DESIGN REVIEW

4721 38th Ave SW
Seattle, WA 98116

April 19, 2018 | SDCI #3028047

^ CONCEPT DIAGRAM

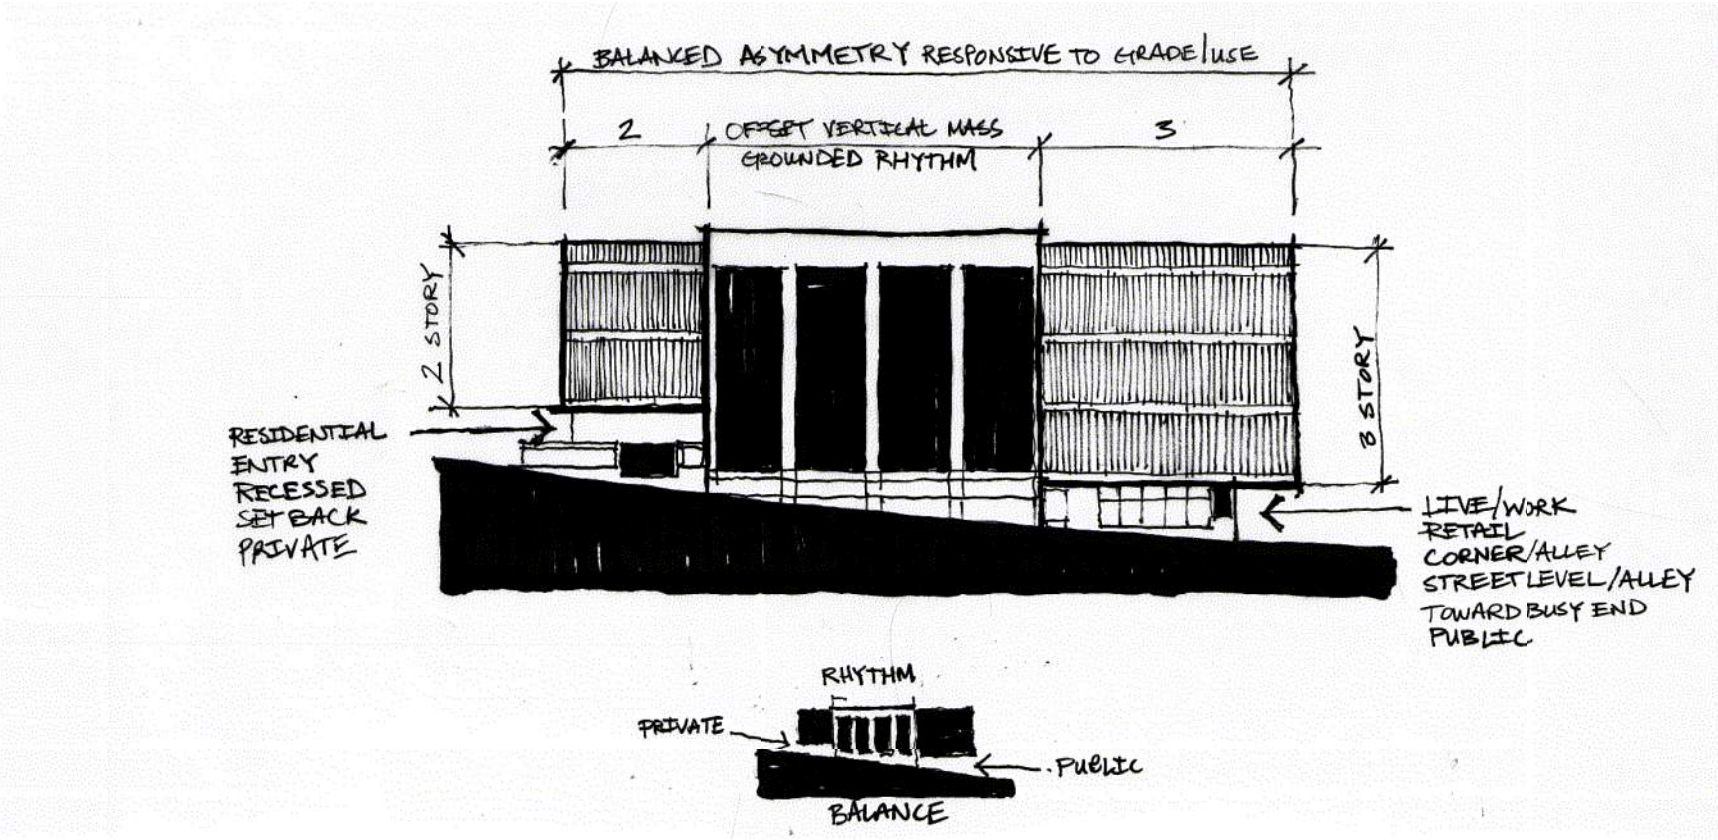
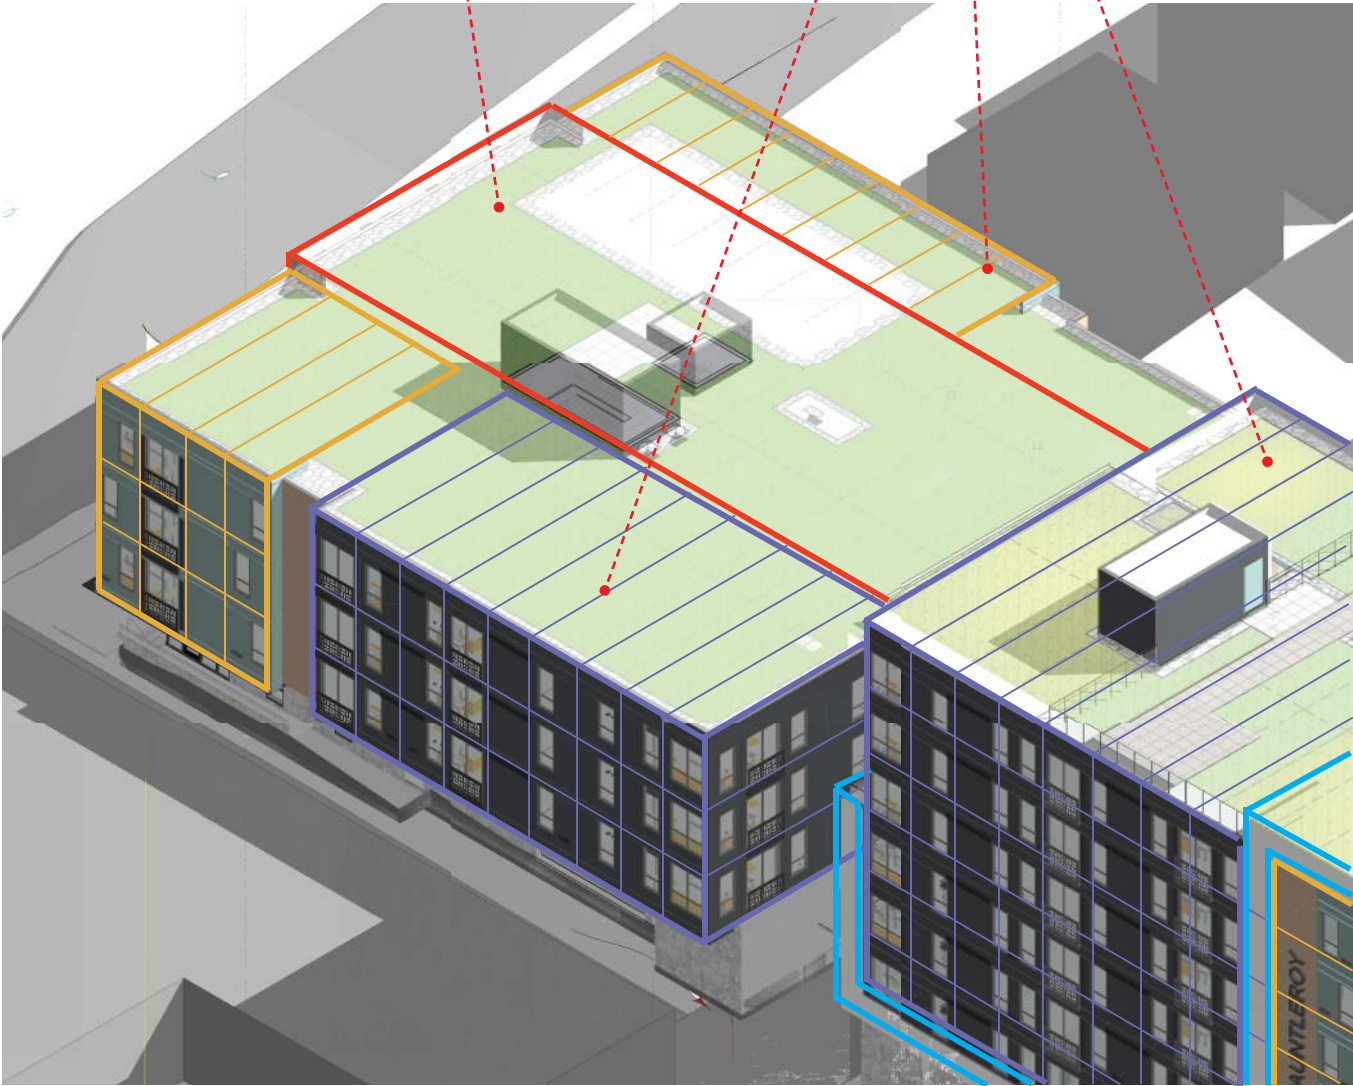
1c. The Board recommended that Site B have a more dynamic expression of The Shift concept specifically, which would result in more than just a superficial relationship to Site A. (DC2-I-ii Cohesive Architectural Concept)

Response: As it relates to the overall concept, Building B is set back from north-south flow along Fauntleroy, providing a more transitional element to the residential neighborhood to the east. As such, it no longer has it's own smaller crane element, but instead relates to the secondary elements of the main building, reinforced through color, materials and proportions.

^ Section AA - Cross Section of Building Courtyards

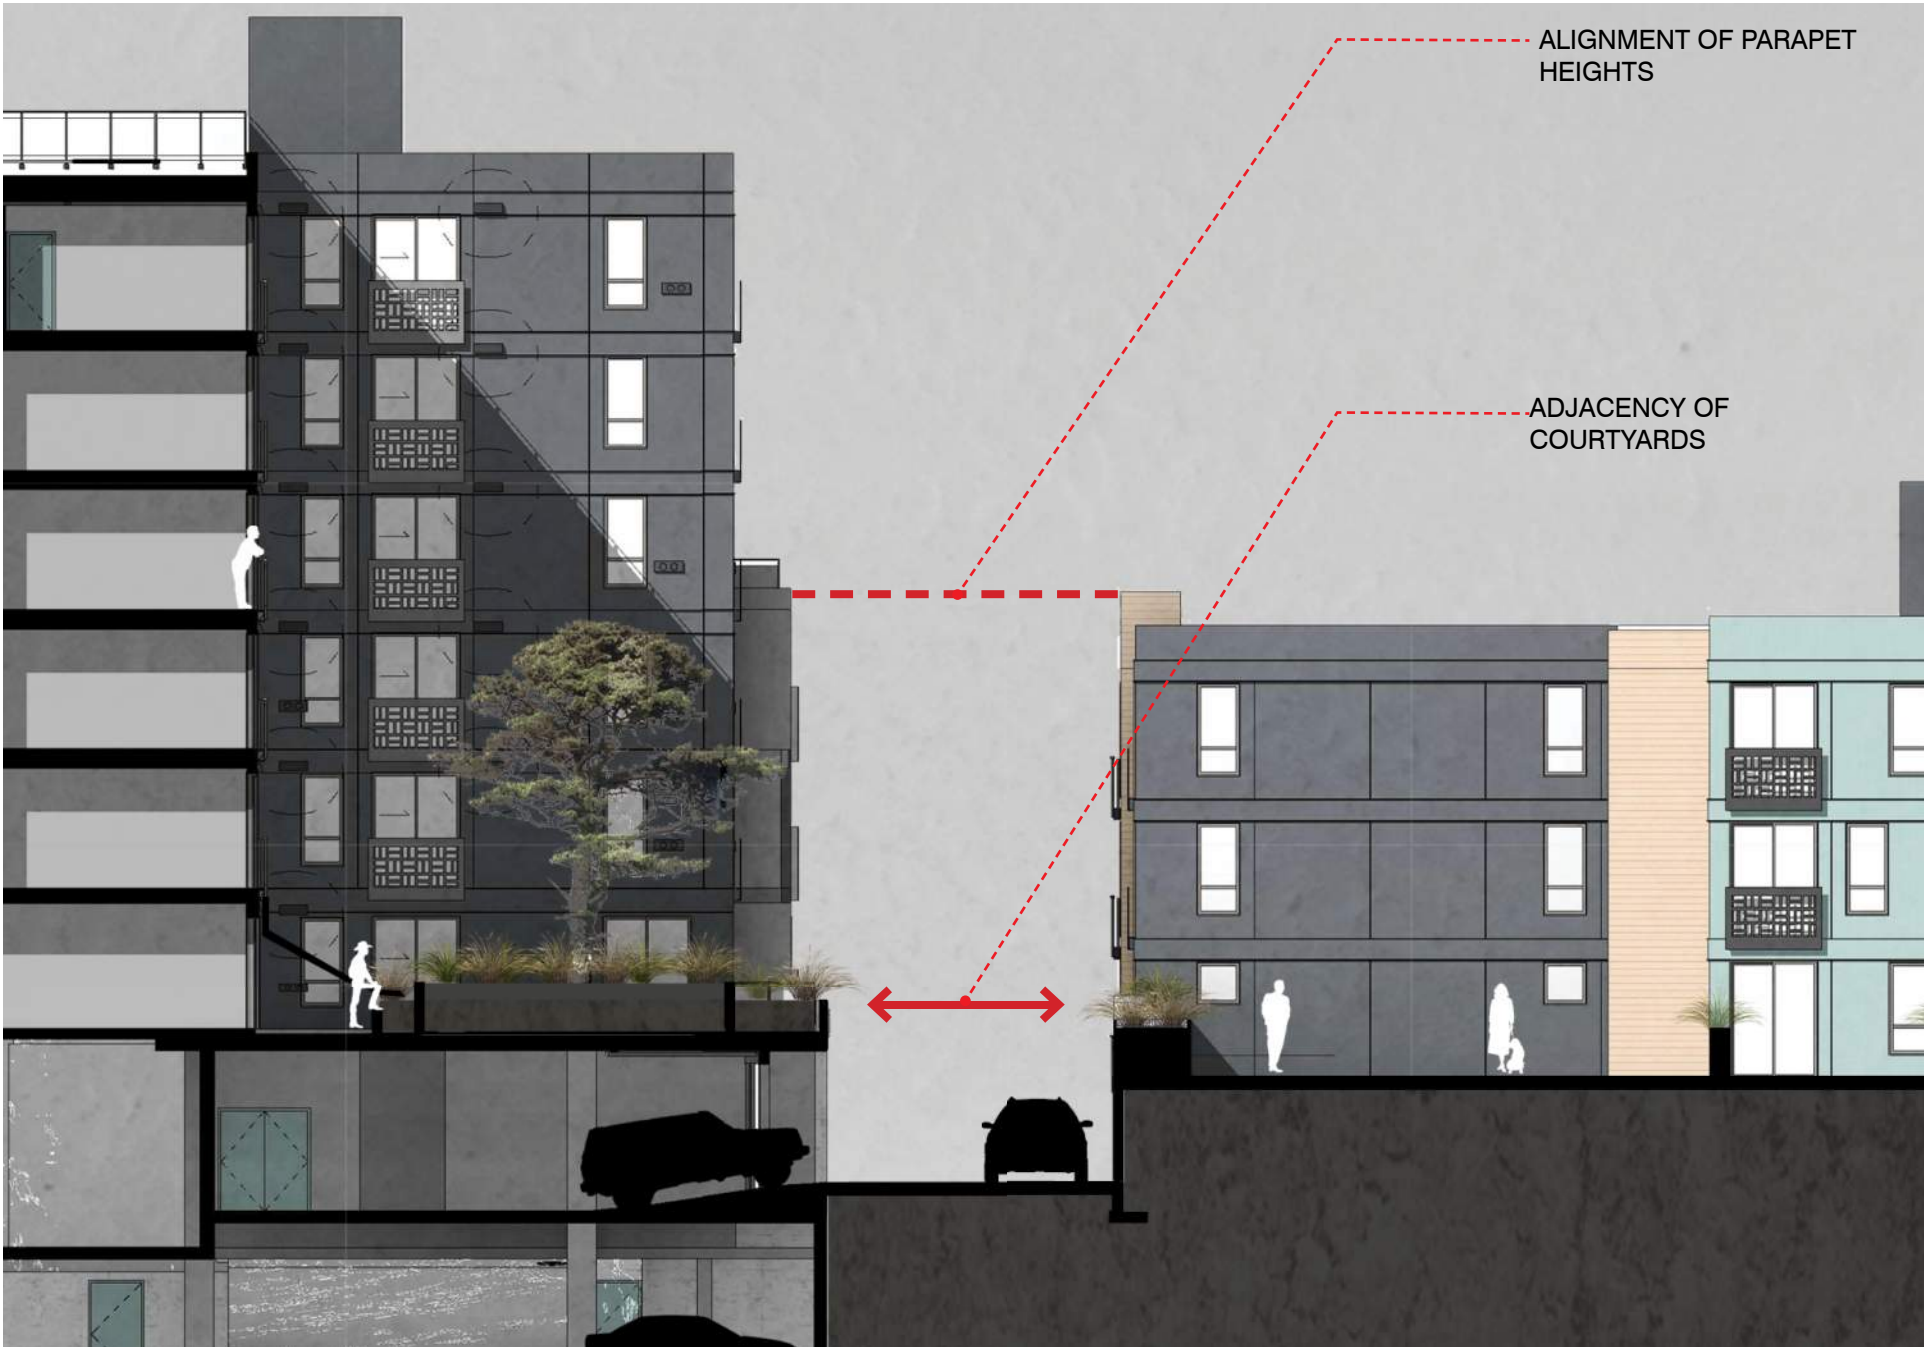
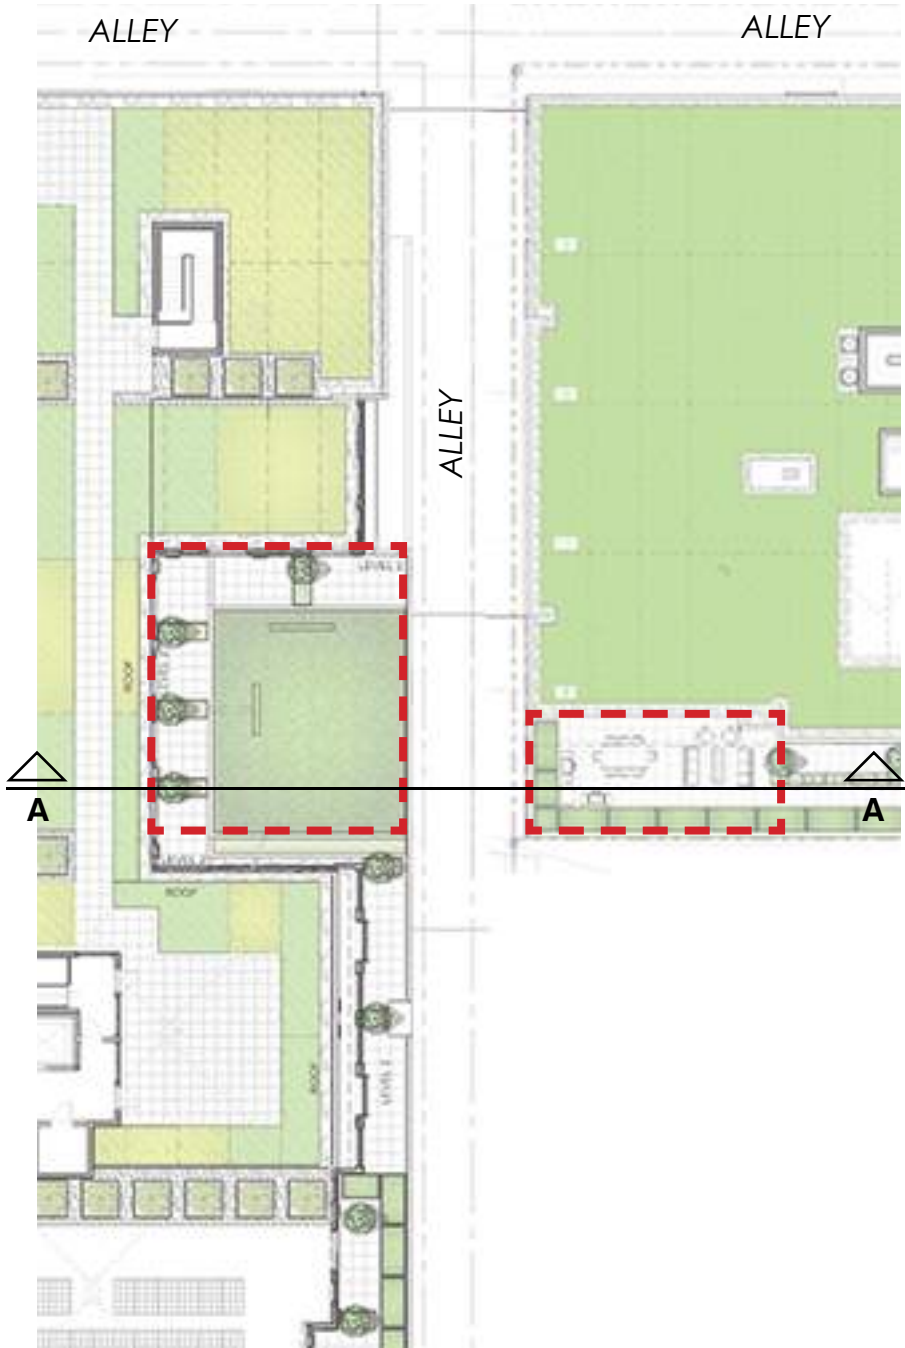
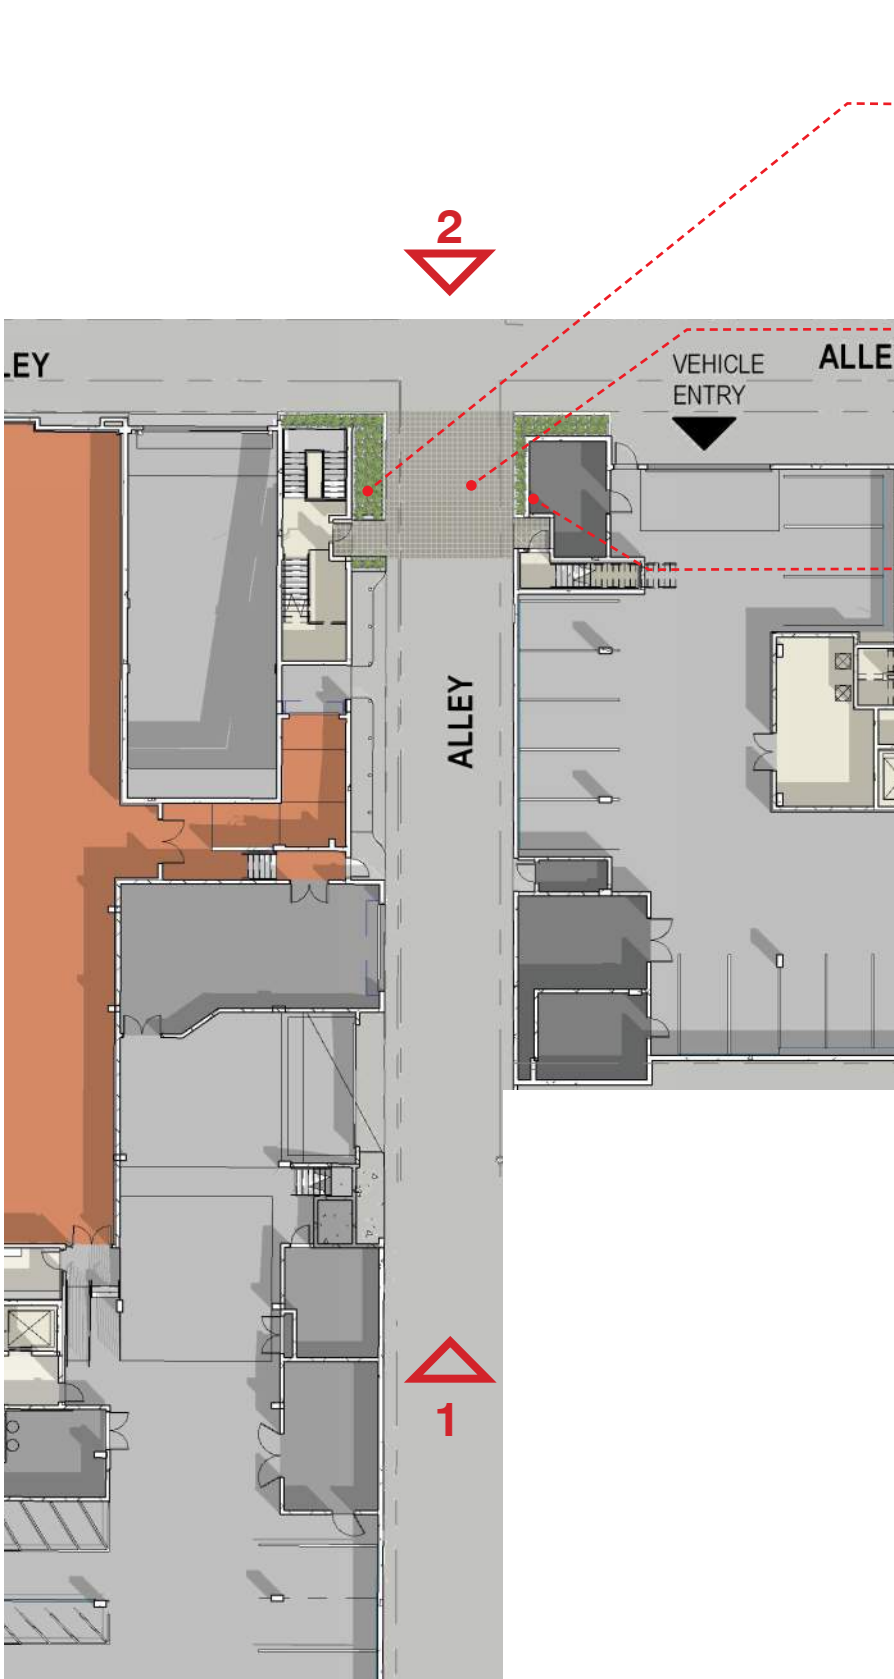
3b. The Board noted that the relationship of Site A and B at the alley is important, with opportunity for the buildings to relate to each other through the massing, scale, placement of courtyards, datum lines, material references, and/or pattern repetition. Design this area to be safe and well lit. (DC2-I-ii Cohesive Architectural Concept, PL2-A-2 Lighting for Safety)

Response: Diagrams showing the relationship between the two buildings is provided on pages 24 and 25.

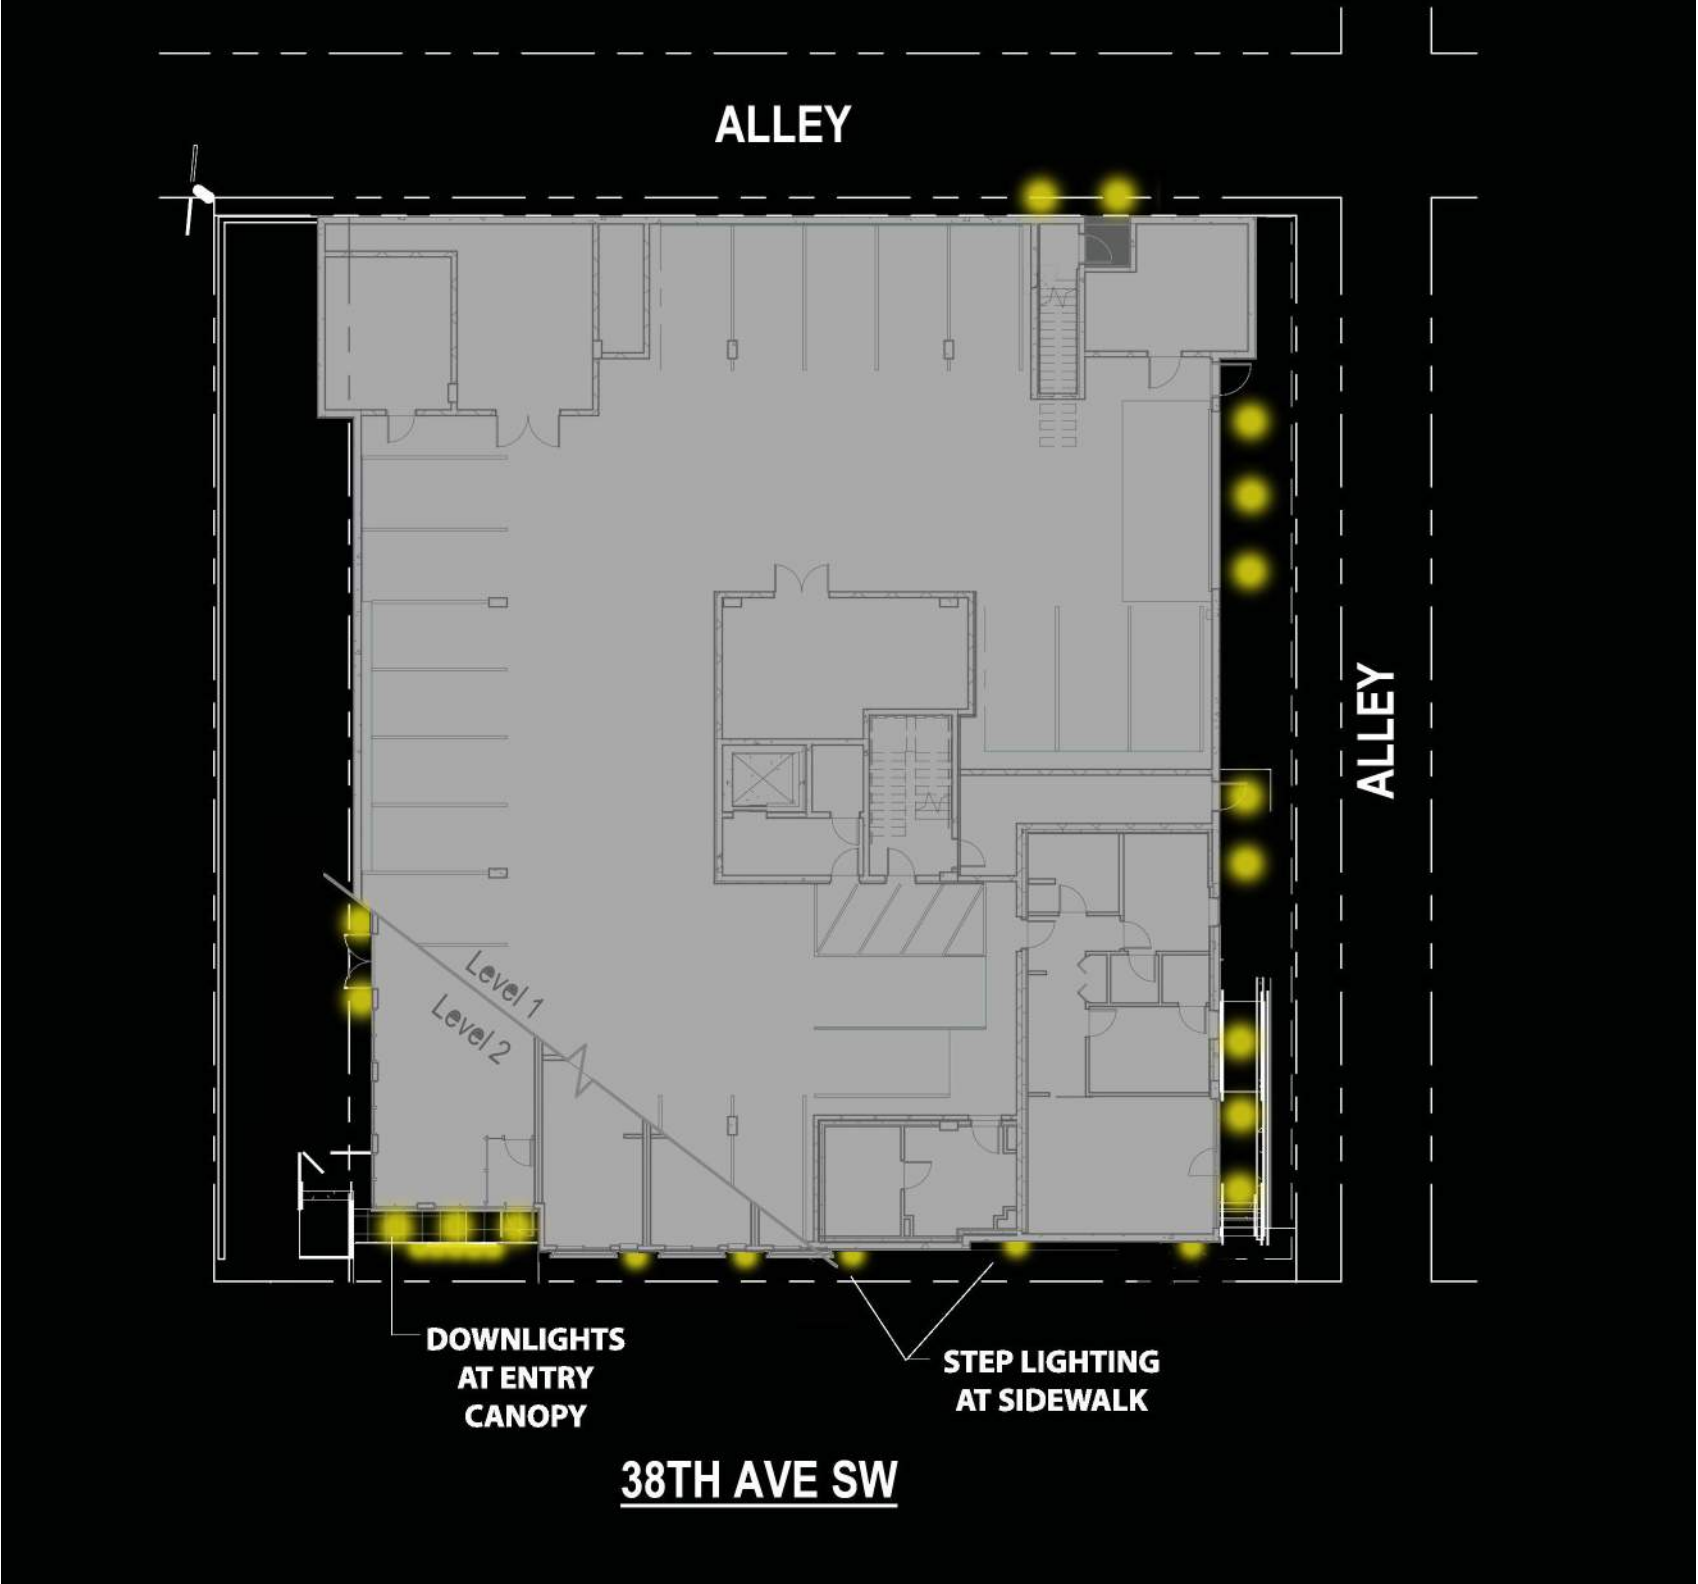
1f. The Board gave guidance that (secondary architectural features) should relate to the design concept. How balconies are detailed and integrated into the concept shall be presented. (DC2-C-1 Visual Depth and Interest)

Response: Architectural features and balconies are shown.
